Access Compliance Report Public Rights-of-Way (Curb Ramps)

Main Street: LIGADO_ST Cross Street: ESENCIA_DR Location: S

ADA ID: RPRK211119115636 Ramp Type: Type 4 - Parallel Initial Pass/Fail: Fail Overall Compliance: No Severity Score: 16

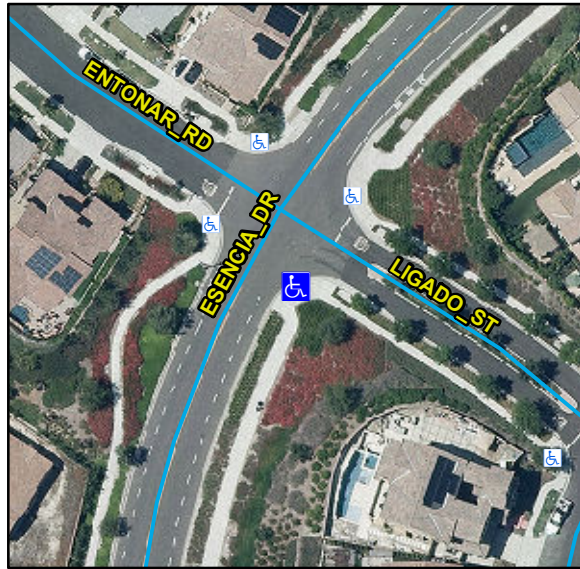
Compliance	Description	Data	Compliance	Description	Data
N/A	Ramp Length LT (in)	108	N/A	Ramp Length RT (in)	111
Yes	Ramp Width LT (in)	120	Yes	Ramp Width RT (in)	120
No	Ramp Run Slope LT (%)	11.9	Yes	Ramp Run Slope RT (%)	5.9
No	Ramp Cross Slope LT (%)	3.4	No	Ramp Cross Slope RT (%)	2.2
N/A	Landing Present	N/A	N/A	DWS Provided	N/A
N/A	Landing Length (in)	N/A	N/A	DWS Contrast	N/A
N/A	Landing Width (in)	N/A	N/A	DWS Length (in)	N/A
N/A	Landing Run Slope (%)	N/A	N/A	DWS Full Width	N/A
N/A	Landing Cross Slope (%)	N/A		DWS Offset Type	N/A
N/A	Landing Movement Obstructed?	N/A	N/A	DWS Offset Left (in)	N/A
	Landing Movement Type	N/A	N/A	DWS Offset Right (in)	N/A
N/A	Landing Shared	N/A			
N/A	Clear Space	Yes			
N/A	Clear Space To Crosswalk (in)	N/A			
N/A	Marked Crosswalk 1	No	N/A	Marked Crosswalk 2	No
	Crossing 1 Direction	NE		Crossing 2 Direction	NW
	Marked Crosswalk 1 Width (in)	N/A		Marked Crosswalk 2 Width (in)	N/A

N/A	Ramp Inside Crosswalk 1	N/A	N/A	Ramp Inside Crosswalk 2	N/A
	Crossing 1 Slope (%)	11.5		Crossing 2 Slope (%)	2
	Crossing 1 Cross Slope (%)	1.7		Crossing 2 Cross Slope (%)	7.3
N/A	Gutter Ponding	N/A	N/A	Curb Slope	8.4
Yes	Gutter Lip Height (in)	0		Road Run Slope (%)	5.5
N/A	Gutter Run Slope (%)	N/A		Road Cross Slope (%)	4.9
N/A	Gutter Cross Slope (%)	N/A	Yes	Perpendicular Joint Present	Yes
Yes	Overall Surface Condition	Acceptable			
	Cross Gutter Present?	No		Spandrel Present?	No
	Replace Cross Gutter?	N/A		Replace Spandrel?	N/A

Remove & Replace Curb Ramp With Two New Directional Ramps or Equivalent.
